S A V A N N A H H I S T O R I C D I S T R I C T
B O A R D O F R E V I E W

REQUEST FOR CERTIFICATE OF APPROPRIATENESS

MPC File No.: 25-002473-COA

Address: 225 West River Street

Staff Site Visit Photos – views of front (West River Street) elevation

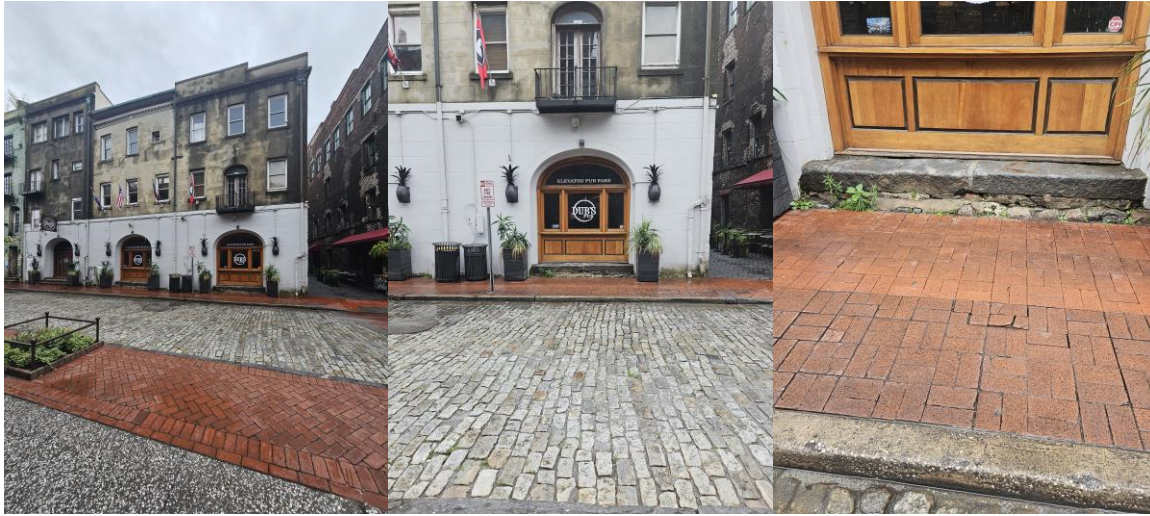
The standards are not met. The proposed scope of work would remove the masonry (granite) base \ ledge to allow for the installation of new masonry (brick) stairs to match those found on the other entrance. To meet the standard, the masonry (granite) base \ ledge should be retained in-place with a new set of stairs added. The proposed replacement of the non-historic wood window with a wood door would meet the standard.

The standard is not met. The proposed scope of work would remove the masonry (granite) base \ ledge to allow for the installation of new masonry (brick) stairs to match those found on the other entrance. To meet the standard, the masonry (granite) base \ ledge should be retained in-place with a new set of stairs added. The proposed replacement of the non-historic wood window with a wood door would meet the standard.

The standard is not met. The proposed scope of work would remove the masonry (granite) base \ ledge to allow for the installation of new masonry (brick) stairs to match those found on the other entrance. To meet the standard, the masonry (granite) base \ ledge should be retained in-place with a new set of stairs added. The proposed replacement of the non-historic wood window with a wood door would meet the standard.

The standard is not met. The proposed scope of work would remove the masonry (granite) base \ ledge to allow for the installation of new masonry (brick) stairs to match those found on the other entrance. To meet the standard, the masonry (granite) base \ ledge should be retained in-place

with a new set of stairs added. The proposed replacement of the non-historic wood window with a wood door would meet the standard.

- 1. Retain the existing masonry (granite) base / ledge and add masonry stairs as needed to provide access to West River Street, with a final design coordinated and approved by staff prior to construction taking place.**
